POWER STEERING OIL COOLER ASSEMBLY

1968-69 MONTEGO AND COUGAR
 Models Equipped with 427-4V or
 428-4V C.J. Engines Built After 6-20-68

(This article cancels and supersedes the article published in 1969 Series Service Bulletin No. 3, dated 9-30-68, same subject).

Fig. 3 - Power Steering Oil Cooler Assembly 9033A

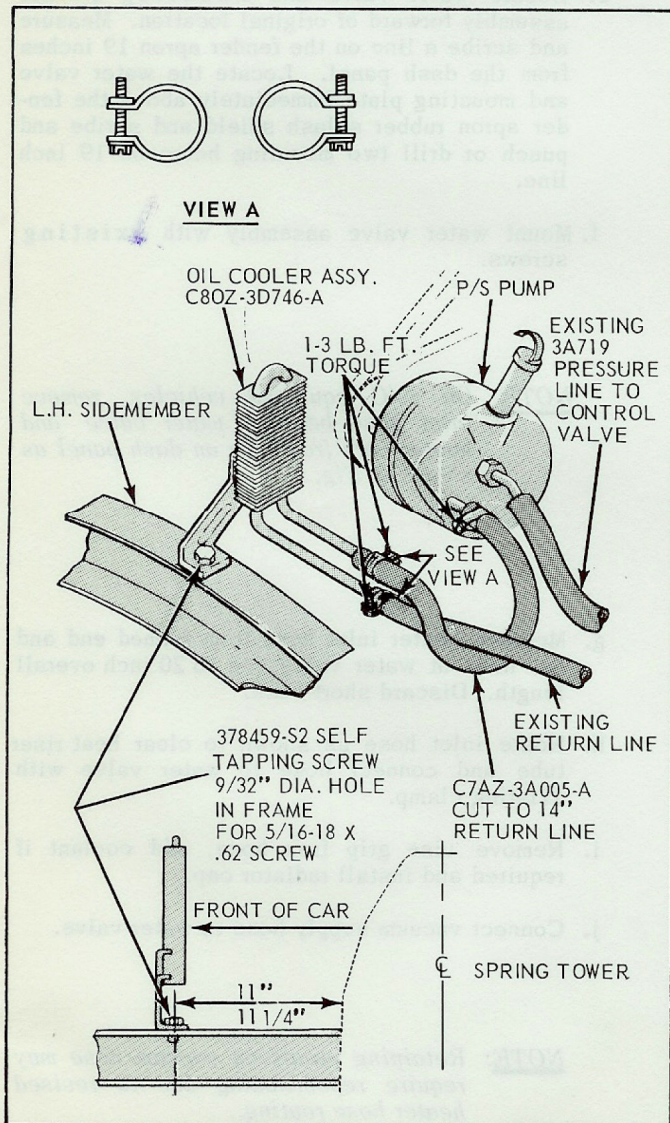
The subject vehicles have incorporated a power steering oil cooler to provide additional fluid cooling due to the higher axle ratios and restricted cooling system used on the 427-4V and 428-4V Cobra Jet engines.

If an overheating power steering fluid condition results on subject vehicles built prior to 6-20-68, a power steering oil cooler assembly should be installed using the following installation procedure:

1. Drill one (1) 9/32" diameter hole in the left side-member forward of the spring tower as indicated in Fig. 3.
2. Install the oil cooler assembly (Part No. C80Z-3D746-A) with a self tapping screw (Part No. 378459-S2) and torque to 7-12 lb. ft. (See Fig. 3).

3. Install the existing power steering return line on the longer tube of the cooler assembly and secure with a hose clamp.
4. Install a 14" return hose (cut from Part No. C7AZ-3A005-A) to the oil cooler assembly and the power steering pump return tube. Secure with hose clamps and torque to 1-3 lb. ft.

NOTE: The clamps installed to the cooler tube must be installed with the heads facing downward. This will preclude possible chaffing of the fuel hose which is routed underneath the cooler clamps.

Fig. 4 - Erratic Ignition Switch Operation 9025A

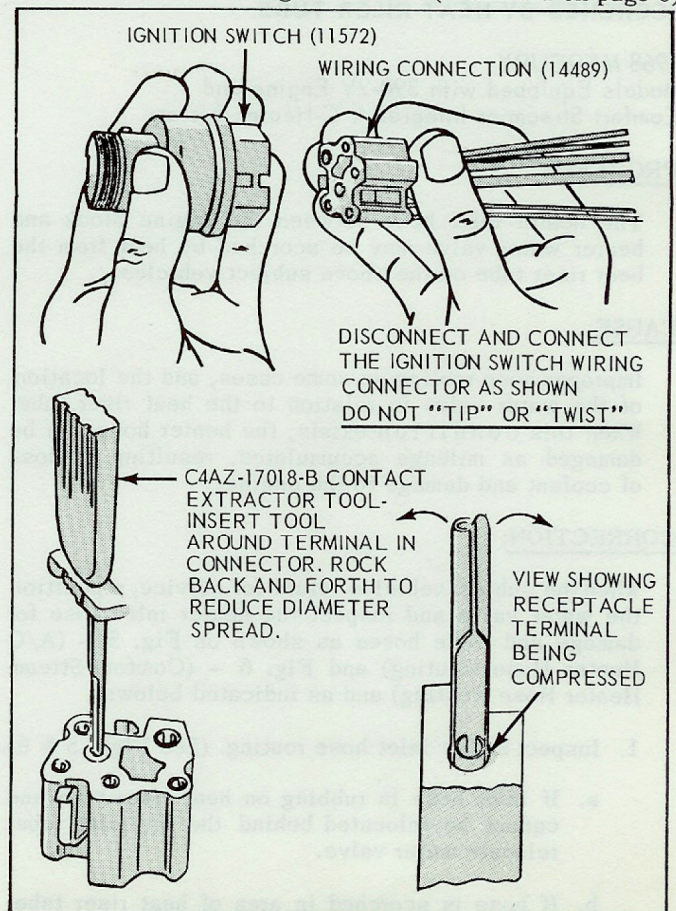
Erratic ignition switch operation.

Improper installation and/or removal (tipping or twisting) of the ignition switch wiring connector. This causes the receptacle terminals within the multiple connector to spread and create a poor connection with the pin terminals.

1. Remove the ignition switch from the instrument panel. (Refer to the appropriate car line Shop Manual, Group 15).
2. Disconnect the wiring connector from the ignition switch. Do not "tip" or "twist" the wiring connector, as this can spread the receptacle terminals in the connector. The connector must be removed on a straight line from the ignition switch as illustrated on Fig. 4. (continued on page 6)
